Dunlin Alpha Decommissioning

Stakeholder Engagement Report

Updated post-statutory and public consultation: October 2021

Doc Number:	FBL-DUN-DUNA-FAC-01-RPT-00006-Rev A2	Revision Date:	1 October 2021
Rev No:	A2	Revision Status:	For use
Revision Description:	Post-statutory and public consultation update		
Next Review Date:	Post-OSPAR Review		
Originator:	Carol Barbone	Checked by:	Jeff Burns
Date:	1 October 2021	Date:	1 October 2021
Signature:	<i>Carol Barbone</i>	Signature	<i>Jeff Burns</i>
Approvals			
Title	Name	Date	Signature
Regulatory Affairs & Stakeholder Engagement Manager	Peter Lee	1 October 2021	Peter Lee <i>Peter Lee</i>

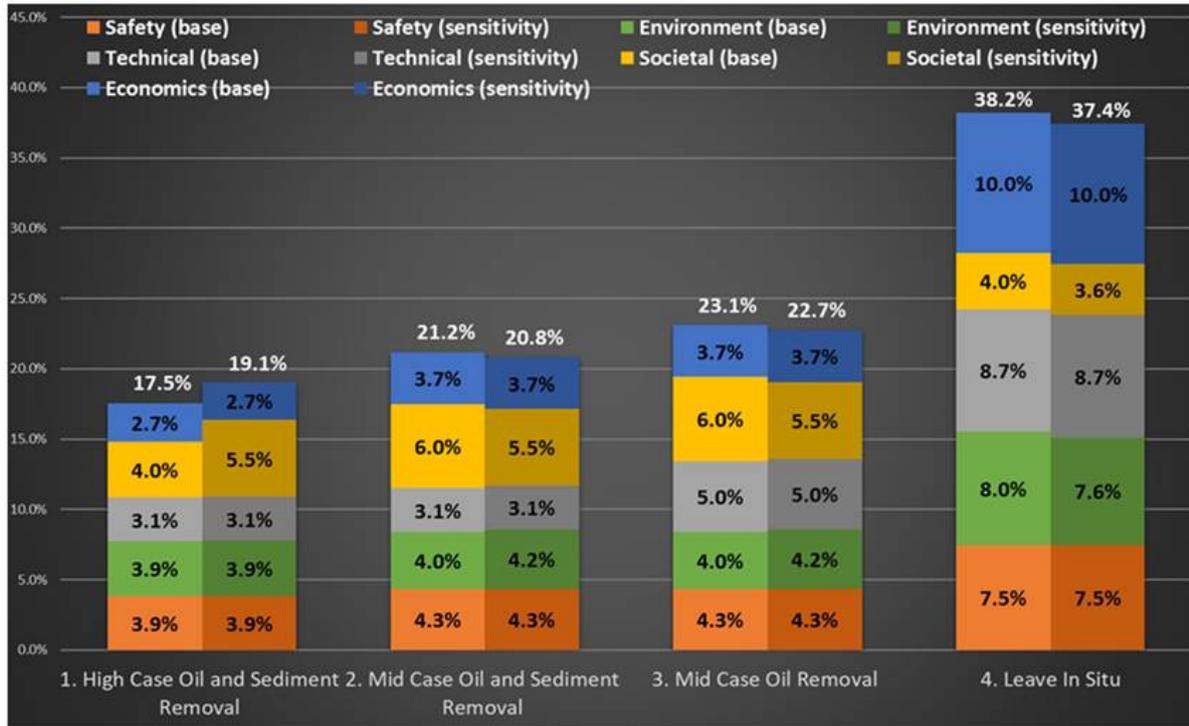
Greenpeace Research Laboratories: (2) I see what is being said here, but I feel that is an artefact of the method...if it is a positive to remove something under one scenario, then the same positive rating should apply if that thing was not there to be removed in the first place. As it stands, it seems that the fact that there is no longer this improvement to be made has counted against that option. In other words, assuming there are no cuttings has pushed one criterion up and another simultaneously down. That seems like a bias. I would be interested to know how the assessment would look if that neutral rating was not applied to offset but instead it was left as a positive, given that the legacy impacts would be expected to be the same for there being no cuttings as there would be in the case that cuttings were there initially but were removed. Otherwise it feels as though Option 1 is in a no-win scenario in relation to this aspect.

Fairfield: As stated earlier, the sensitivity analysis portrayed in section 6.4.2 was based on disregarding the drill cuttings in the evaluation of cell content management options. This sensitivity was conducted to better understand whether the best long term management option for the cells was dependent or independent of the presence of the drill cuttings. With drill cuttings disregarded, the relative merits of each option will naturally change. It would be inappropriate to only disregard the cuttings when it favours a particular option. Put in simple terms, keeping the virtues while ignoring the disadvantages of a single option would seem like the very definition of bias. Building on your point regarding a positive to remove something staying a positive if that thing is not there to be removed in the first place, why would that positive (ie no cuttings present) only apply to option 1? Options 2, 3 and 4 could also lay claim to this positive, if somewhat fictitious, assumption. As a result, the comparative assessment of the options on this aspect would rightly be neutral – just as we concluded in the sensitivity analysis.

That said, your comments made us reflect on why there was any discernible improvement in option 1 under the environmental criterion for the ‘no drill cuttings’ sensitivity. While the wording in table 6.4 accurately reflects the sensitivity case we performed and describes how the two environmental sub-criteria offset one another, and how the societal evaluation of option 1 improved as a result of not bringing large volumes of drill cuttings ashore for processing, we have realised that the bar chart actually portrays the set of assumptions you have proposed. For clarity, the stacked bar chart which shows the environmental evaluation increasing from 3.9% to 4.3% is already based upon the following inputs:

As outlined above, we believe that the above suite of assumptions is demonstrably biased in favour of option 1. As the text and chart are not precisely aligned, we propose to revise the Comparative Assessment Report to include the bar chart which should have been presented in table 6.4. This will show that the environmental evaluation for option 1 was unchanged under the ‘no drill cuttings’ sensitivity analysis, with the only difference in the overall assessment being from the societal benefit of no longer handling the drill cuttings waste stream. We have included the correct chart below and apologise for the error in the original report. In summary, we would contend that the long term management option for the Dunlin cells is insensitive to any assumptions on the presence or management of the drill cuttings.
